DPR 22-10: Bubba's 33 Development Plan

Planning & Building Department Staff Report

RE: DPR 22-10 Bubba's 33 Review #1

To Crossroad Engineers, PC Gregory J. Ilko - Engineer 115 N 17 th Avenue, Beech Grove In, 46107 317-780-1555 gilko@crossroadengineers.com	Project: Bubba's 33 – Avon, IN Re: Response Letter to Development Plan Review Comments Project #: DPR 22-10
--	--

CLIENT	PROJECT NAME	BUBBA'S 33	PROJECT ADDRESS	NWQ ROCKVILLE RD. & N. COUNTY ROAD 900 E AVON, IN	PROJECT NUMBER	20210223.0	SHEET TITLE	EXTERIOR ELEVATIONS	SHEET NUMBER	A2.1
						DATE	06/01/2022	SCALE: 3/32" = 1'-0"	RH 7.575 SF	1 OF 1

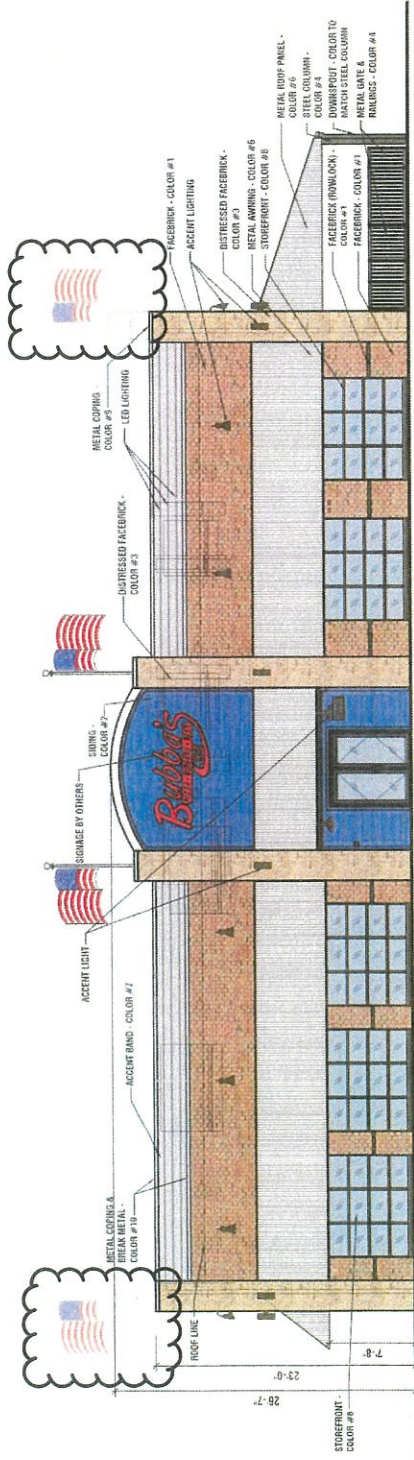
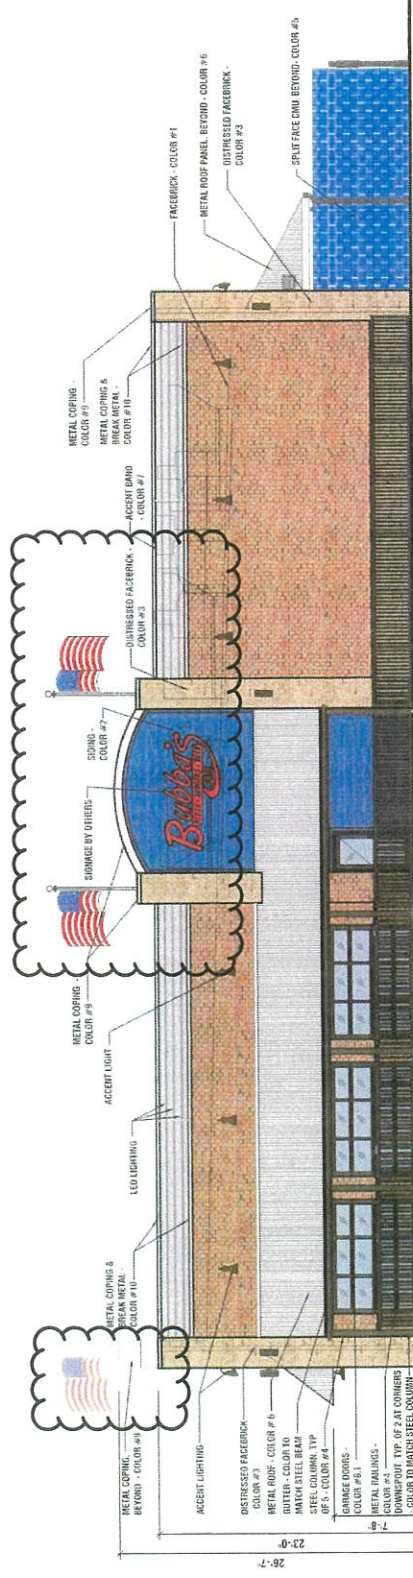
The proposal would have some building articulation at the entrances and at the corners of the building, but these articulations would not extend at least three feet from the façade nor extend for 20 feet. The petitioner has argued that they incorporate metal awnings that extend from the façade approximately five feet and serve the purpose of providing interest and distinction to the façade. Staff concurs with that assertion.

Waiver Request: We ask that Staff and the Plan Commission consider our building's permanent metal awnings and permanent metal roofs, which are over the outdoor patio and dumpster enclosure area, as wall plan projections. The permanent metal awnings are on the front (south) and left (west) building elevations. These permanent metal awnings occur every 40-feet, have a depth that is greater than 3-feet and a width that is greater than 20-feet. The permanent metal roofs are on the right (east) and rear (north) building elevations. These permanent metal roofs occur every 40-feet, have a depth that is greater than 3-feet and a width that is greater than 20-feet.
Applicant must demonstrate compliance with the following:

SHEET NUMBER
L1.0

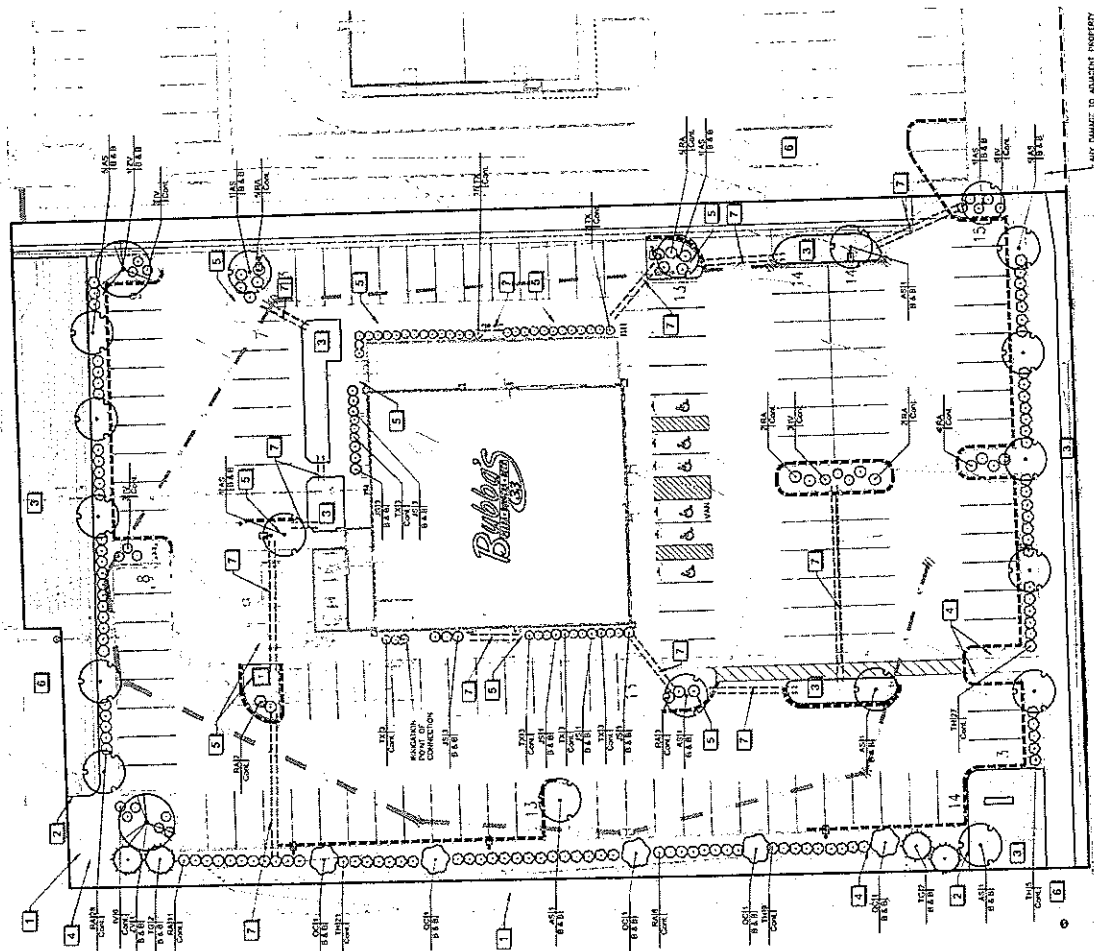
- e. The request does not appear to be consistent with Section 6.6 of the Ordinance, since it appears that the petitioner has substituted shrubs for the required trees. Under the UDO, trees can be substituted for shrubs, but not *vice versa*.
